Stallan-Brand

Date: 25/03/2024

2027.00 Moss Lane East, Manchester

Design and Access Statement Addendum

Ground Floor Plan as Amended

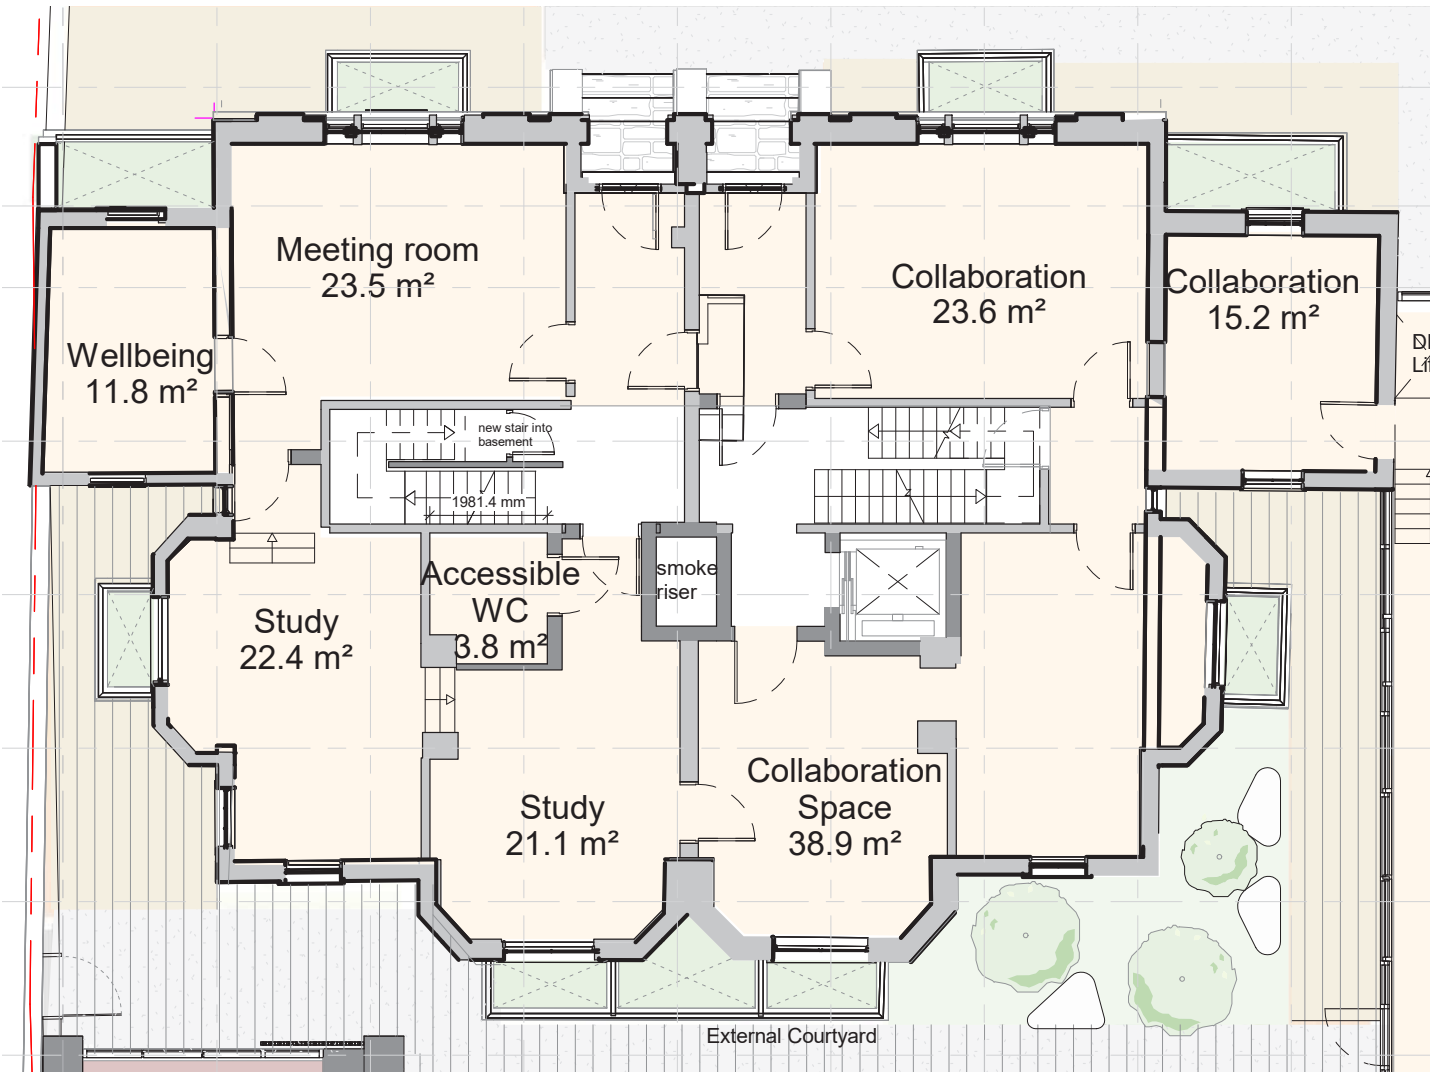
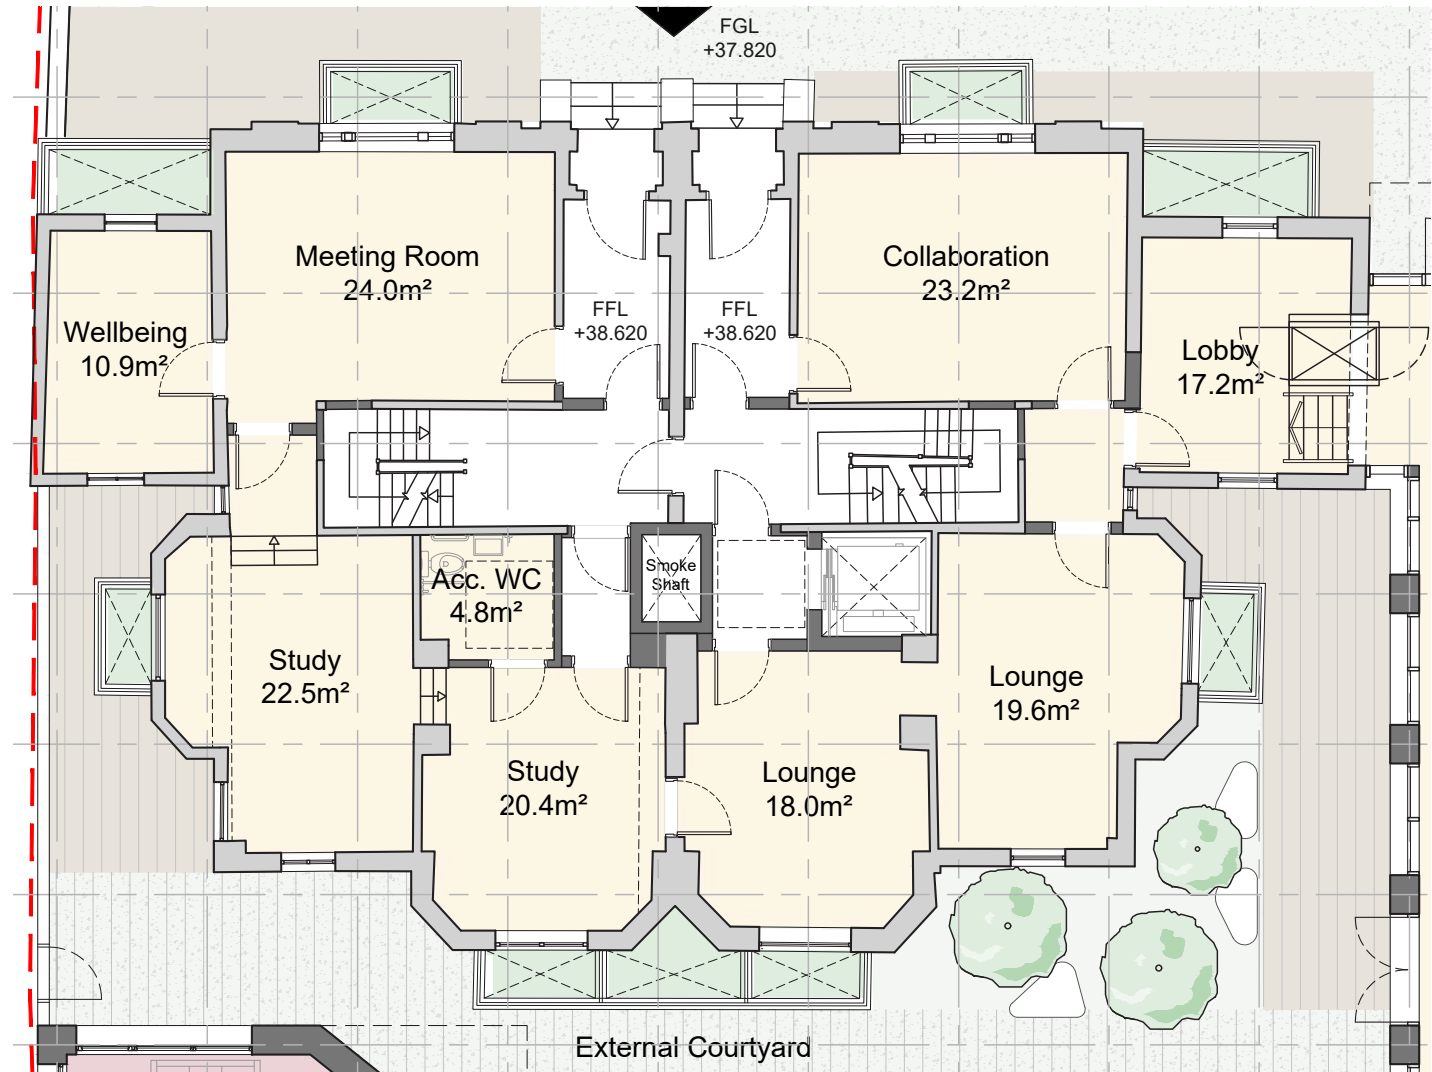
To align the proposed layouts with statutory requirements for fire safety, the following has been proposed -

- Adjustments to Ground Floor amenity layouts

- Ground Floor layout reconfigured by additon of internal walls and doors to provide safe fire escape from the building

Ground Floor Plan as Amended

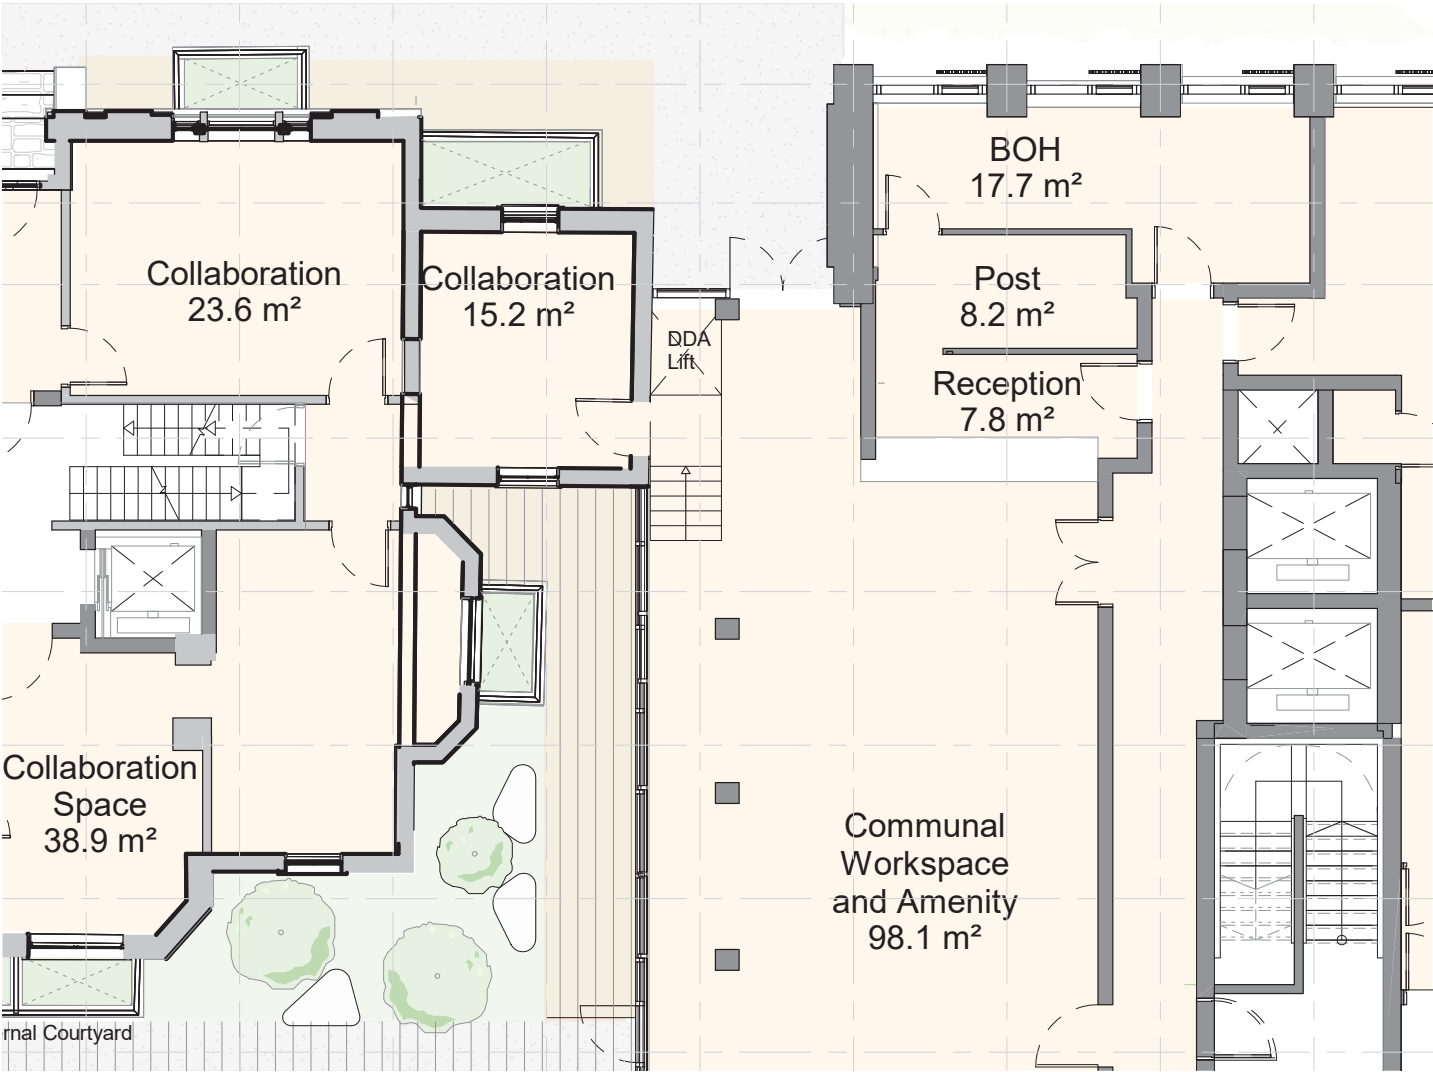
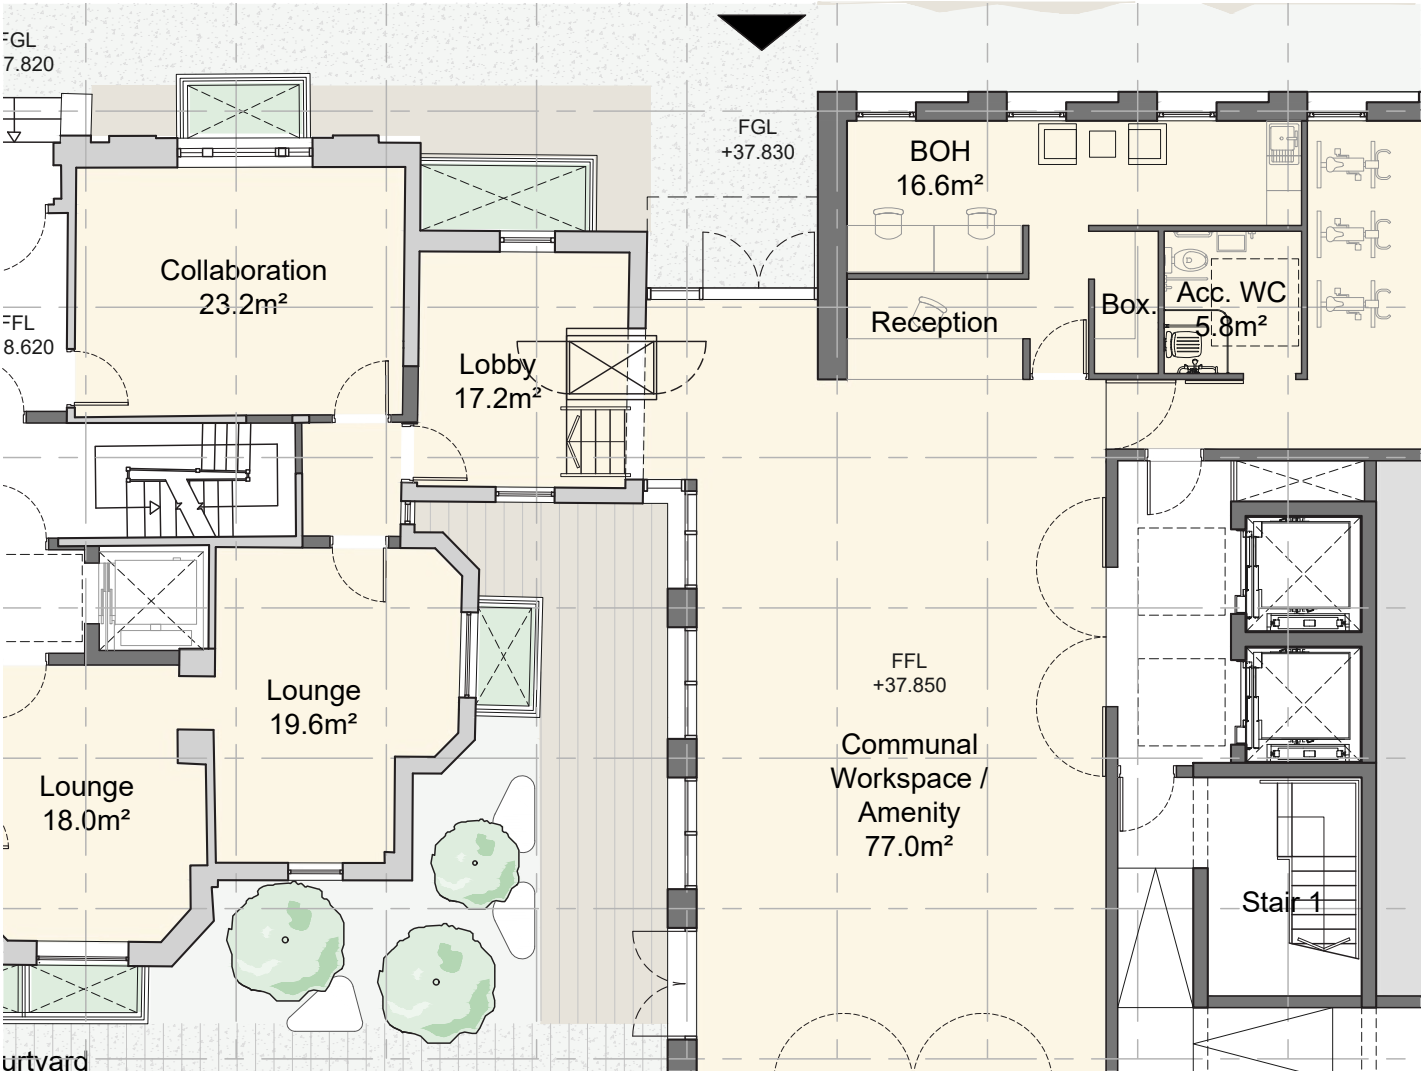
To ensure Building Regulations compliance and improve the proposed link access arrangement in conjunction with the wider ground floor diagram, the following has been proposed -

- Reconfiguration of link access stair and platform lift

- Access stair and platform lift relocated to within the listed building footprint and their layout adjusted
- Newly formed opening in the existing east gable wall of the listed building increased in size to accommodate the above
